Re: Request of Ocean State Holdings of Middletown, LLC (Hyundai of Newport) for approval of a revised landscape plan associated with a previously approved Development Plan Review application, including relocation of a stone wall on property located at 1215 West Main Road, Tax Assessors Plat 106, Lot 91.

Re: Landscaping Plan for Proposed Hyundai Dealership West Main Rd., Middletown

LANDSCAPE PLAN

L1.0

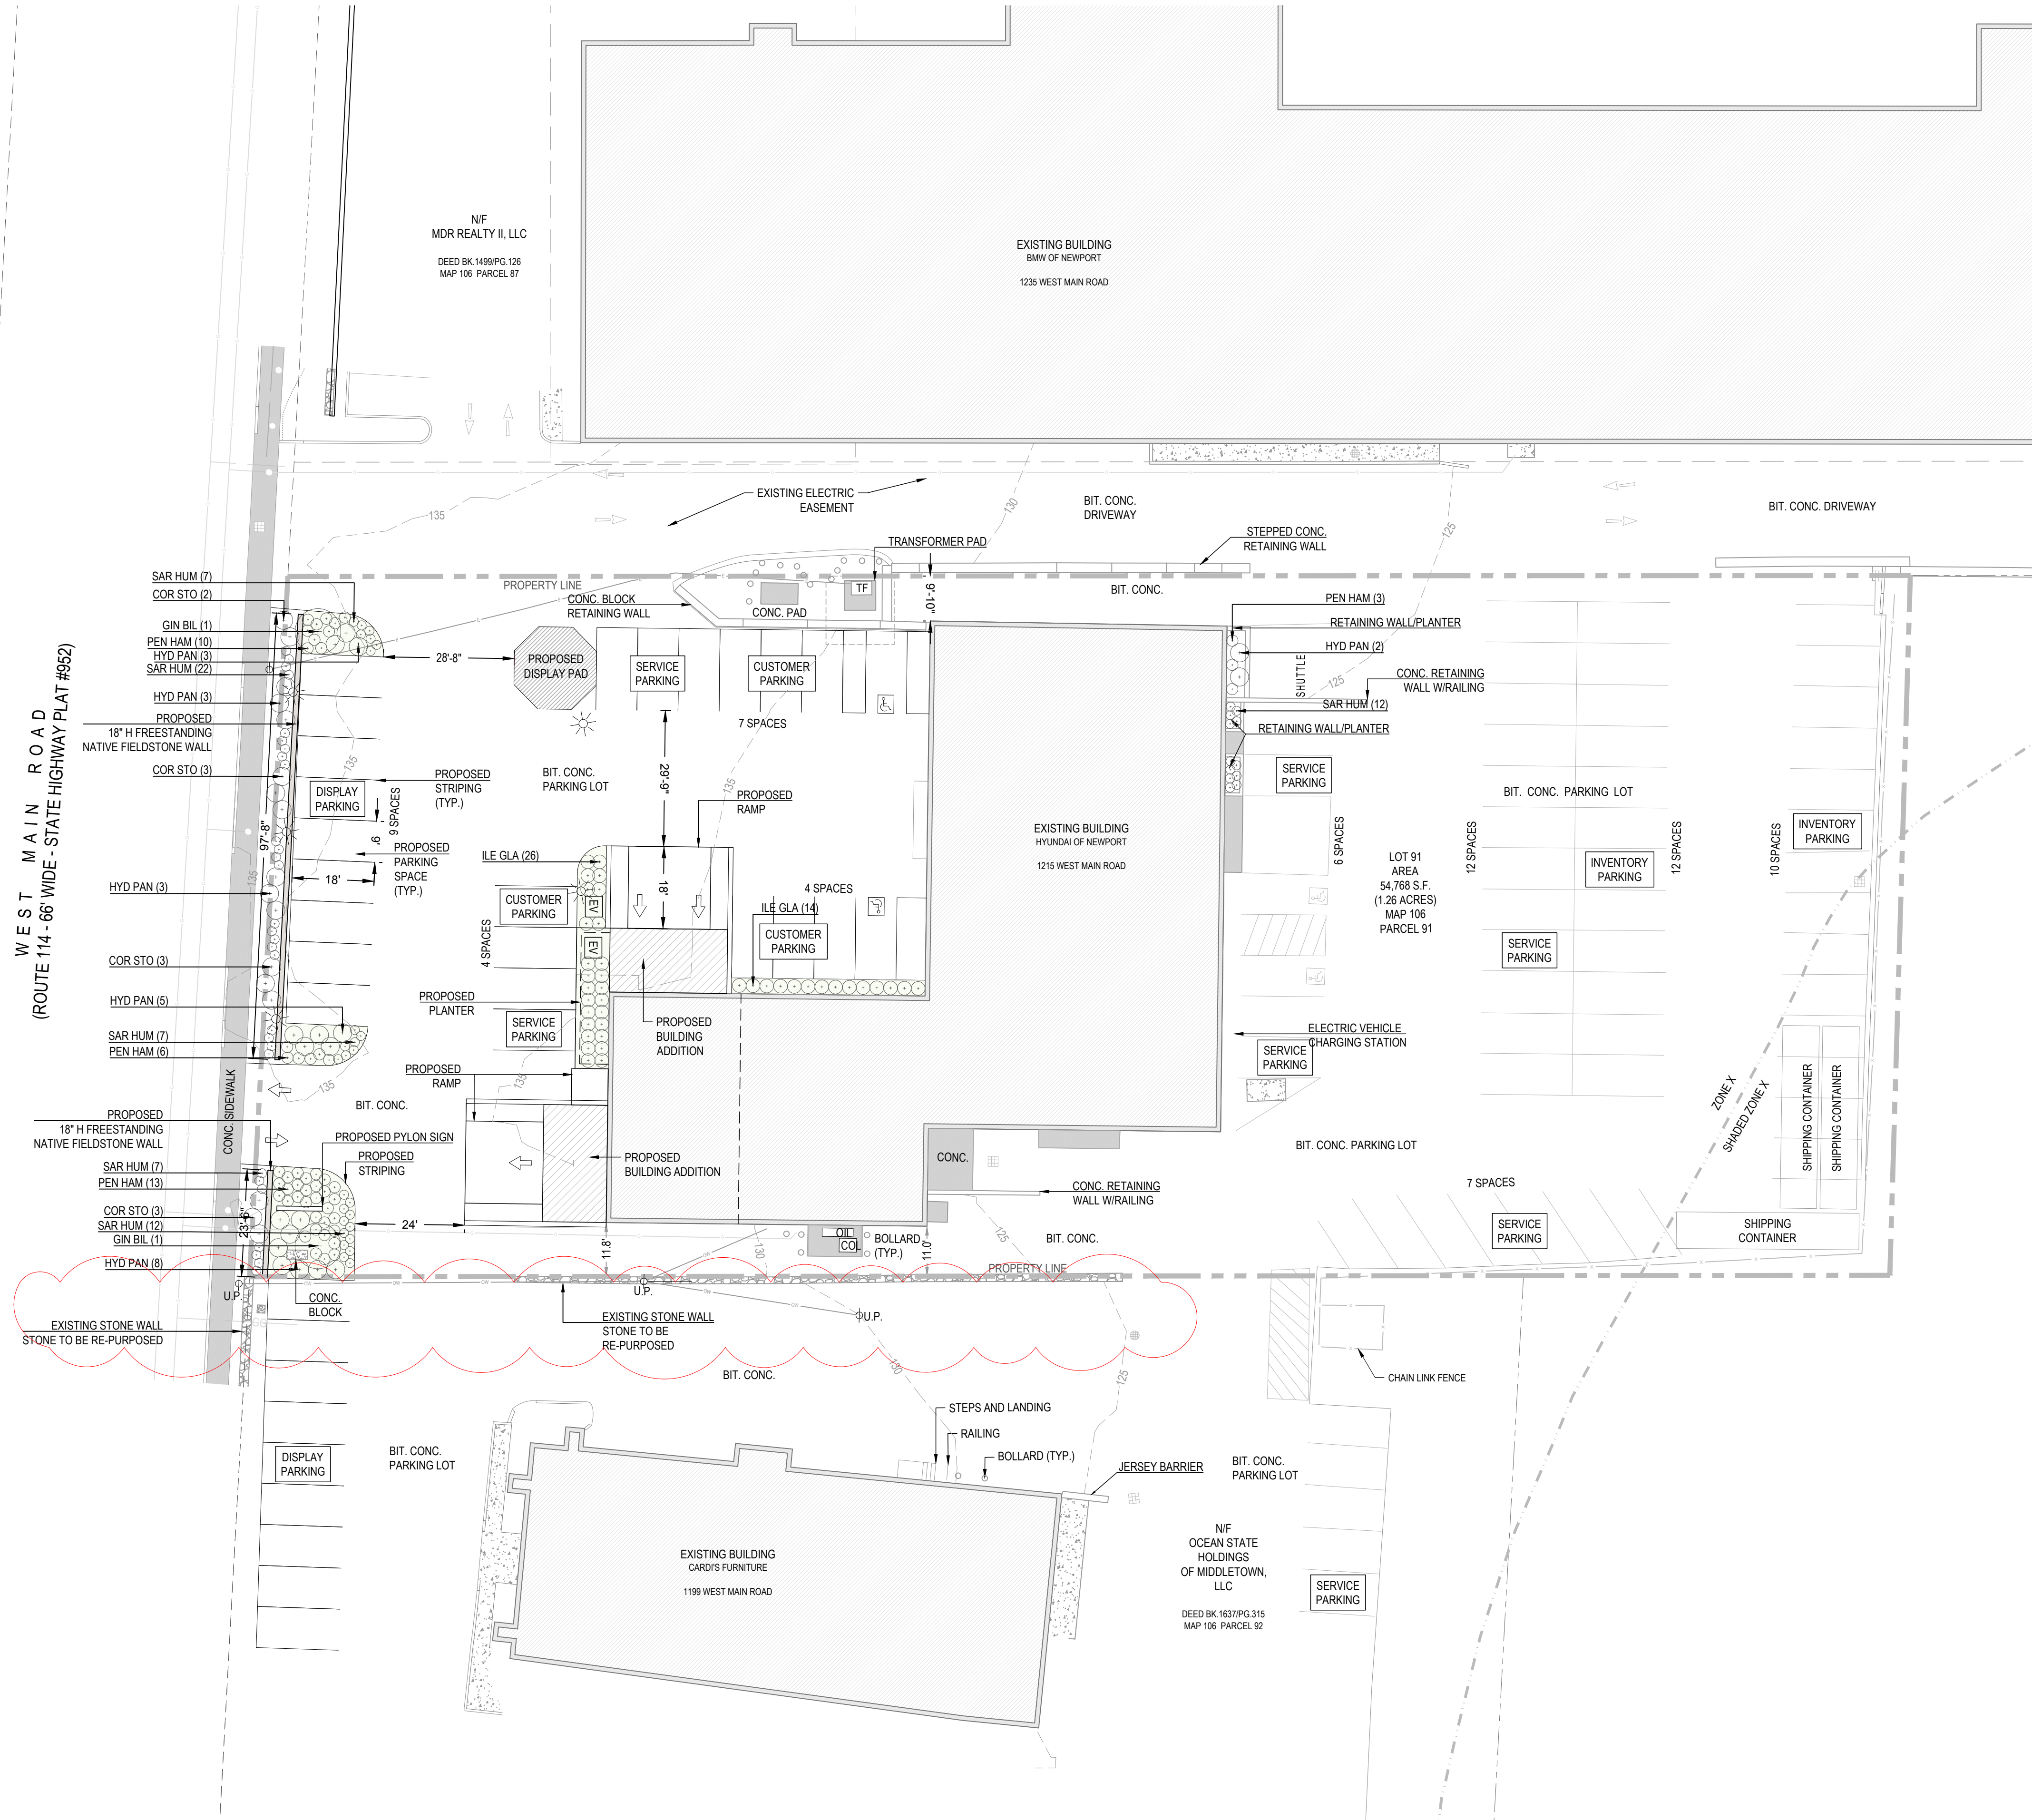
- Hyundai Dealership: We reviewed the revised landscape plans which reflected changes in the previously approved plans. We appreciate very much the additional plantings included in the new plan and feel it will add a softer appearance in that area of West Main Road which is sorely needed. We understand the owner did not have to adjust his plan and we are delighted he has chosen to support our efforts to make that area of Town a bit greener.
